August 19, 2022

Re: PZC #22-12SITE and #22-14CAM
Garrett Homes, LLC Site Plan Application
1682 & 1686 CT Route 12, Ledyard, CT

We are in receipt of staff comments via an email dated 8/11/2022, and Town Engineer's comments dated 8/8/2022, regarding the project noted above. Our responses are shown in ***bold italic*** text. One copy of the following items have been included for your review in conjunction with this letter:

National Flood Hazard Layer FIRMette

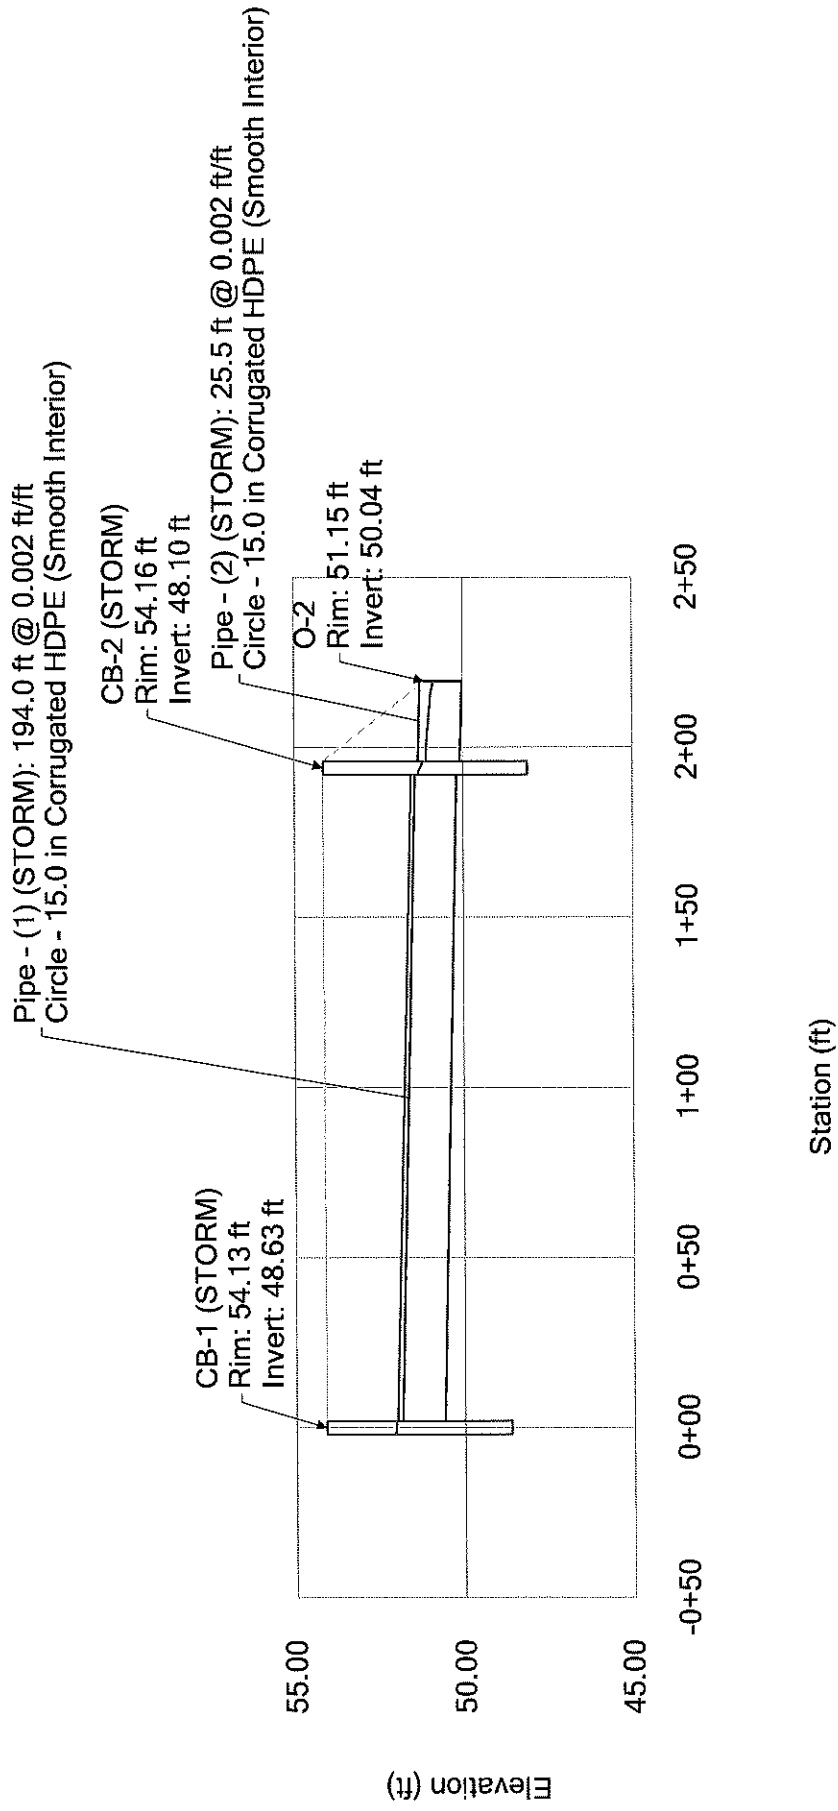
2. Plans and Stormwater Management Report.
a. Appendix A: Figure 3 (FEMA Flood Insurance Rate Map) is illegible.

Response: *A new FEMA Flood Insurance Rate Map is attached to this letter for reference.*

Profile Report
Engineering Profile - CB-1 (STORM) to O-2 (C-CALC-2102412-Proposed Hydraulics-REV 1.stsw)

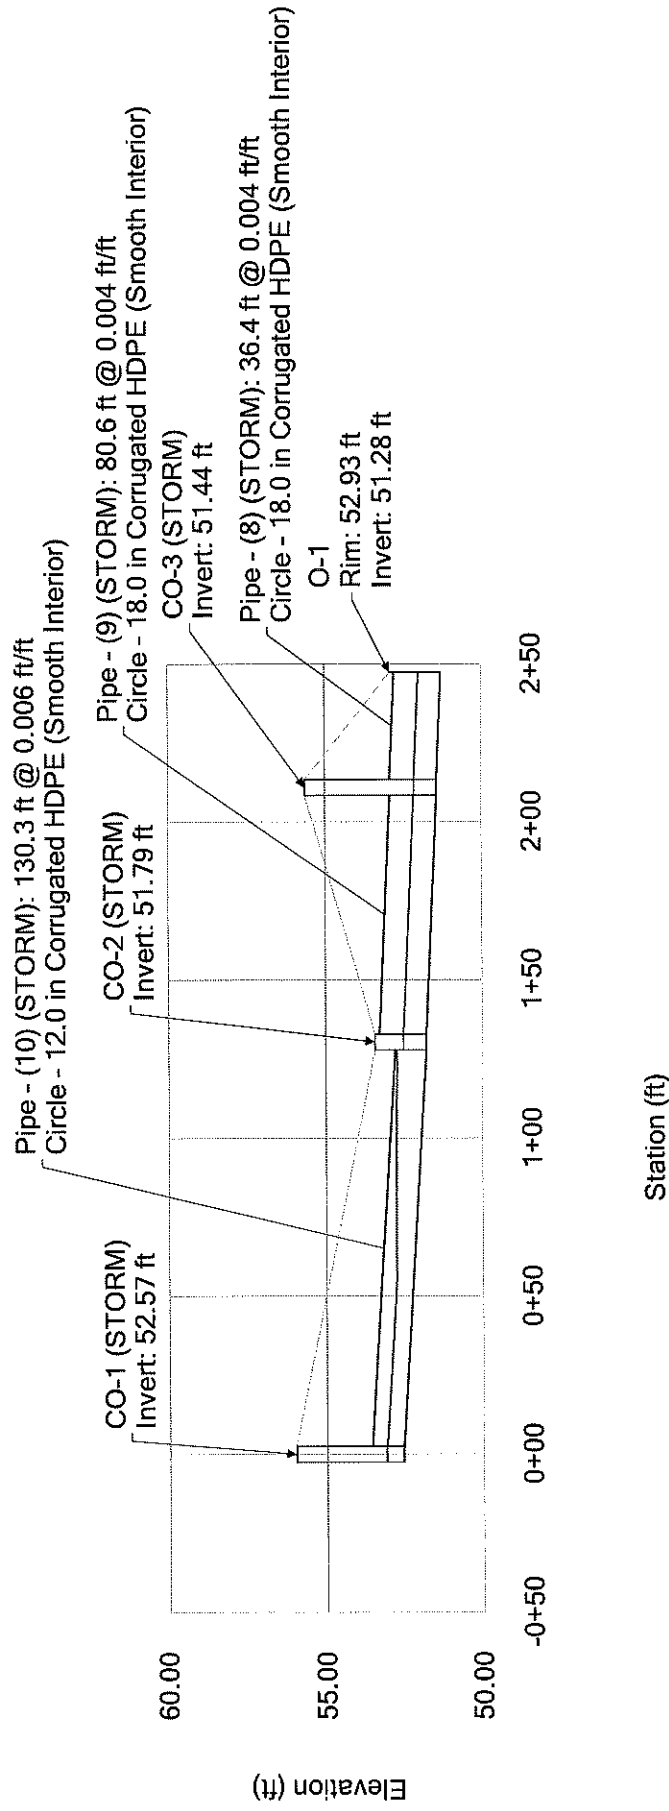
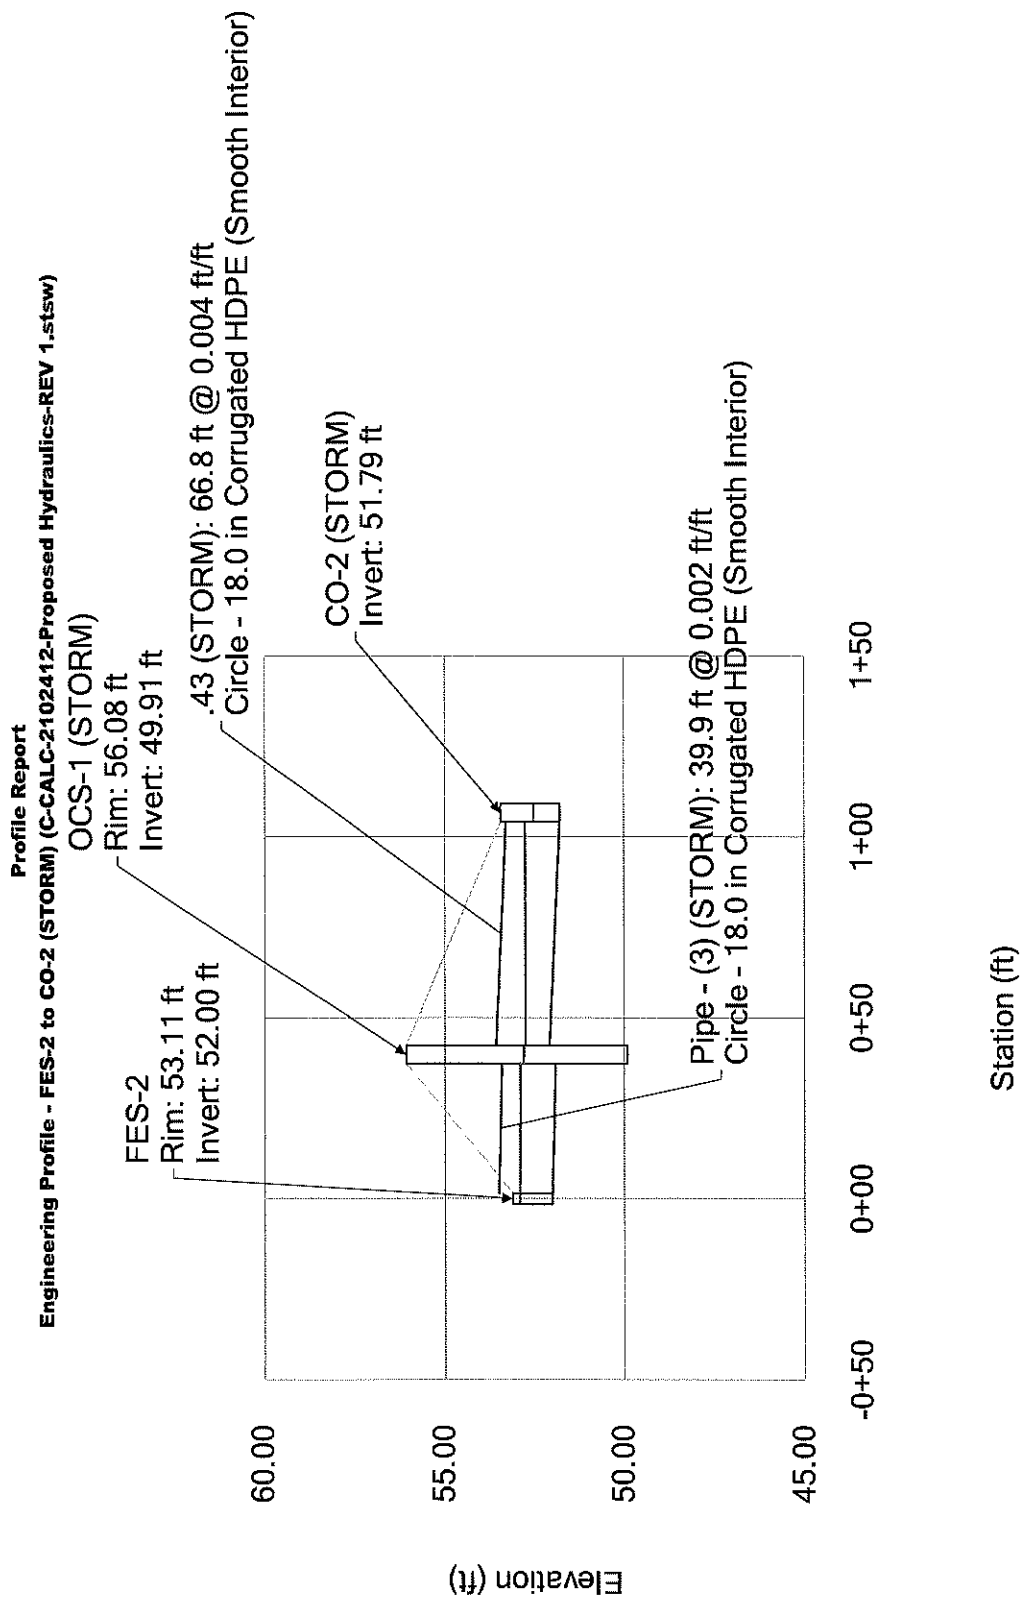
- c. Disparities Between Drainage Plans and Stormwater Management Report Appendix D. There are a number of miscellaneous minor editorial inconsistencies in values (particularly pipe length) that are relatively insignificant, but the following are notable and should be reconciled.

Plans	Report Profiles/Table
12" Downspout Collection Pipe (10)	155 feet	130.3 feet
CO-1 Invert	52.57	52.44
CO-1 TF Elevation	55.97	53.19
CO-3 TF Elevation	55.63	53.08

Response: *The report profiles and table have been revised to match the elevations and pipe lengths on plan sheet GD-1. Revised table and profiles are attached for review.*
